OUR CHANGE PROPOSAL

Re: PCO 11 for **Electrical building code upgrades**

Project: Colchester Senior Center

Clarification(s): - Electrical Building code upgrades, changes to plans E101,E201,E202,E501 & E502

Drawing Title:
ATTIC PLAN - POWER

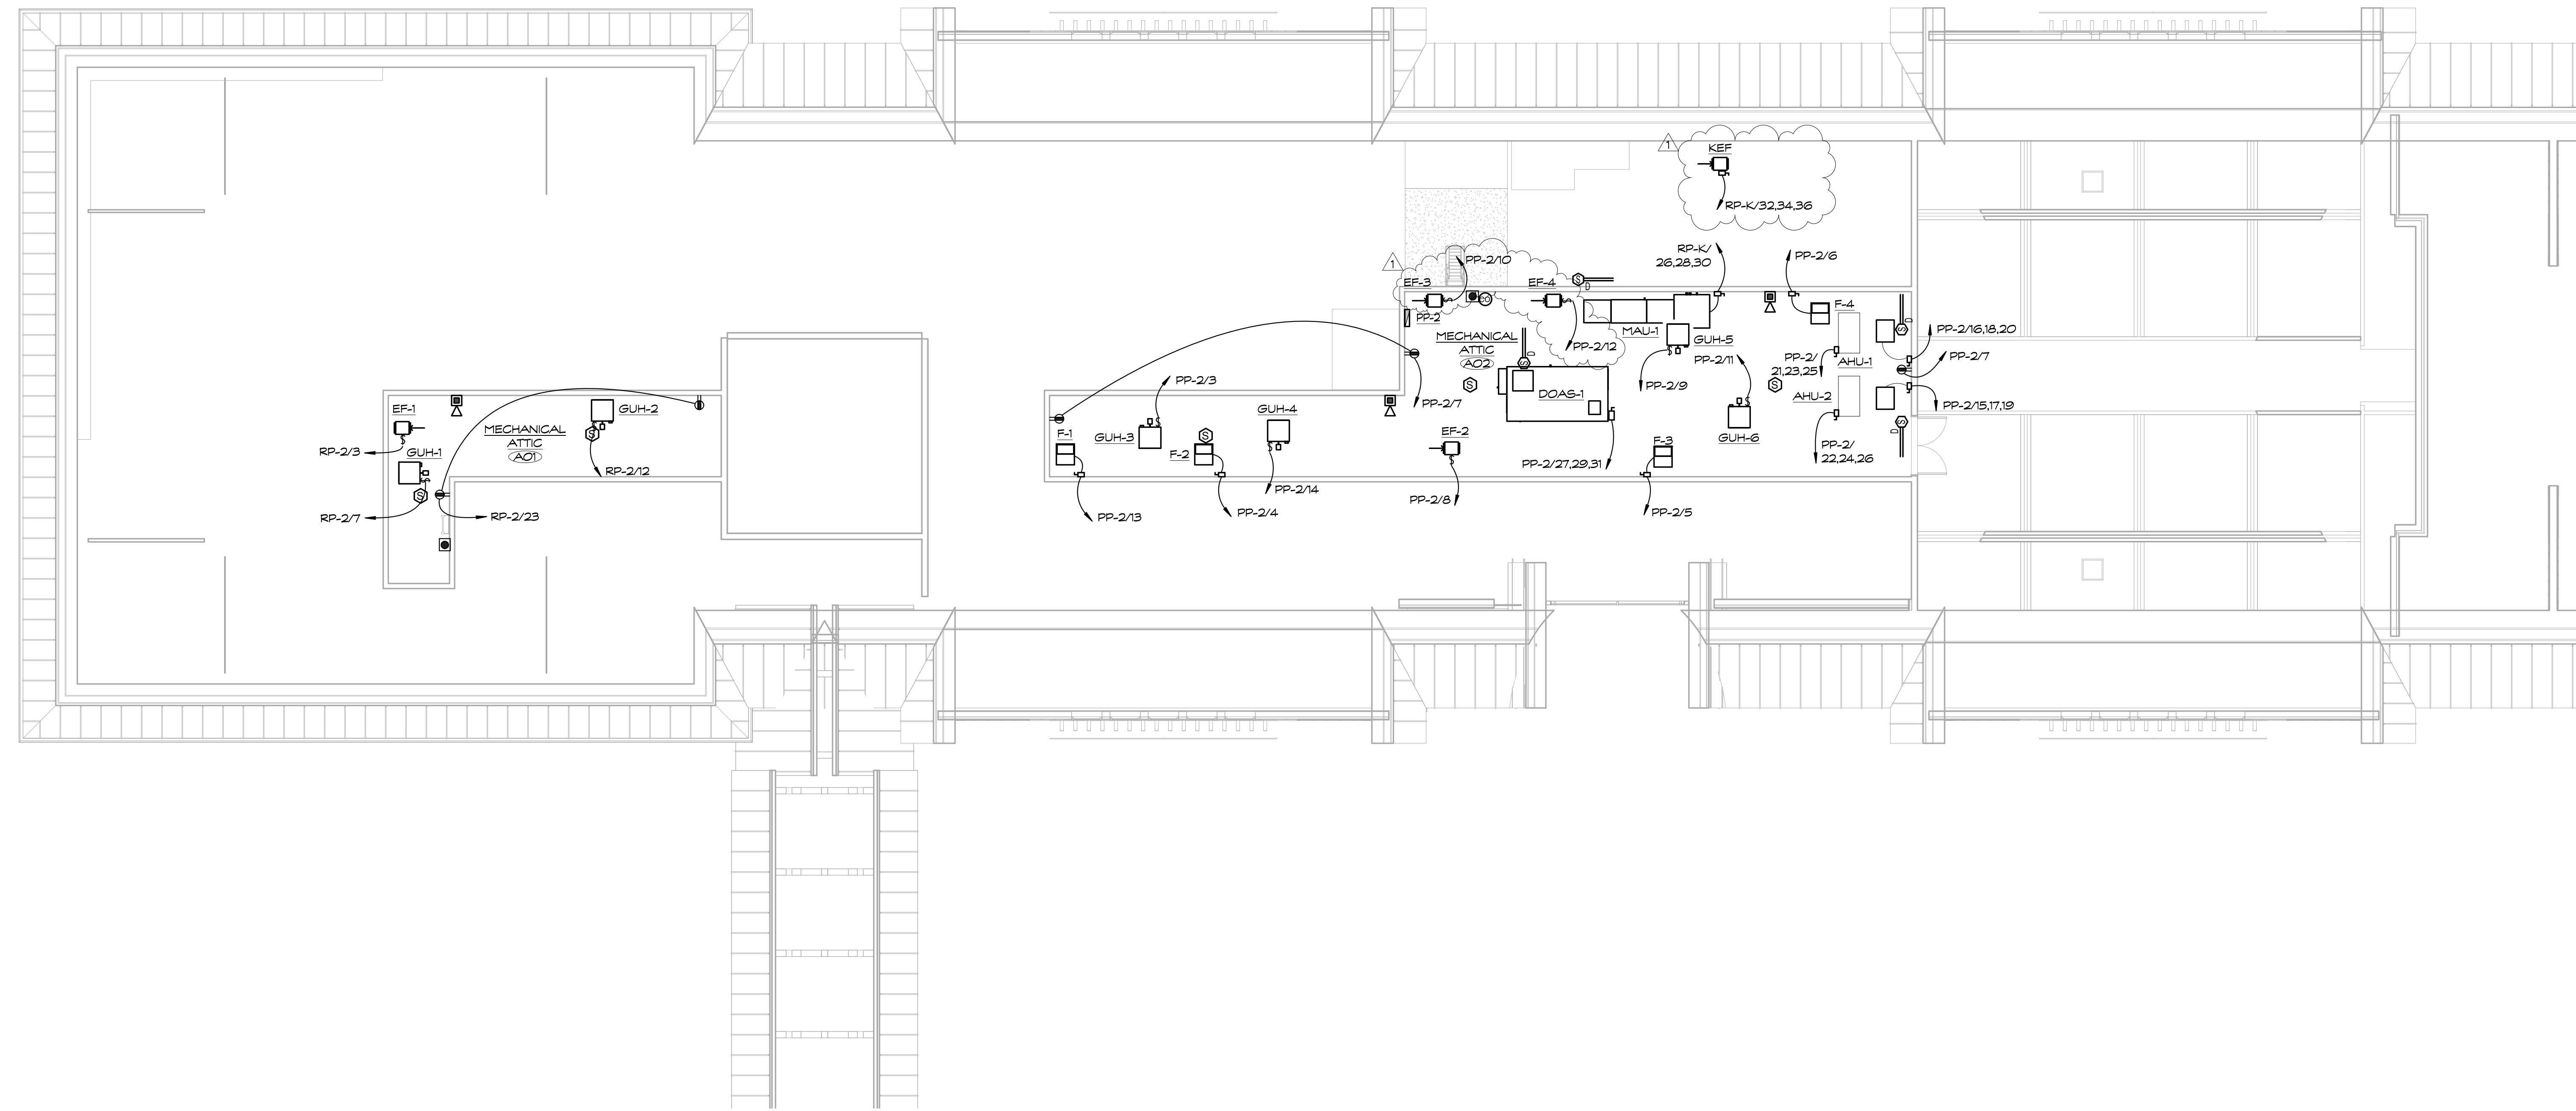
Revision:	Description:	Date:	Revised By:
1	ISSUED FOR BID	09/09/2022	
2	CODE REQUIREMENT	04/14/2023

Power	47030 VA	100.00%	47030 VA	Total Conn. Load: 53526 VA									
Receptacle	5796 VA	100.00%	5796 VA	Total Est. Demand: 53701 VA									
				Total Conn. Current: 149 A									
Notes:													
ALL BREAKERS SERVING HEAT TRACE AND DISHWASHING EQUIPMENT SHALL BE GFI TYPE BREAKERS.
